SUBJECT: FAU Route 1321 (IL 19)

Section 31RS-9 (15) DuPage County Contract No. 62A52

Item No. 26, June 10, 2016 Letting

Addendum A

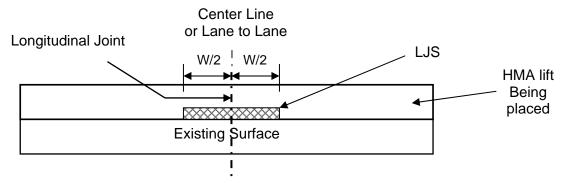
A notched wedge longitudinal joint shall be used between successive passes of HMA binder course that has a difference in elevation of greater than 2 in. (50 mm) between lanes on pavement that is open to traffic.

The notched wedge longitudinal joint shall consist of a 1 to 1 1/2 in. (25 to 38 mm) vertical notch at the lane line, a 9 to 12 in. (230 to 300 mm) wide uniform taper sloped toward and extending into the open lane, and a second 1 to 1 1/2 in. (25 to 38 mm) vertical notch at the outside edge.

The notched wedge longitudinal joint shall be formed by the strike off device on the paver. The wedge shall then be compacted by the joint roller.

When using a notched wedge joint, the bituminous material specified for the mainline tack coat shall be applied to the entire face of the longitudinal joint immediately prior to placing the adjacent lift of binder. The material shall be uniformly applied at a rate of 0.05 to 0.1 gal/sq yd (0.2 to 0.5 L/sq m).
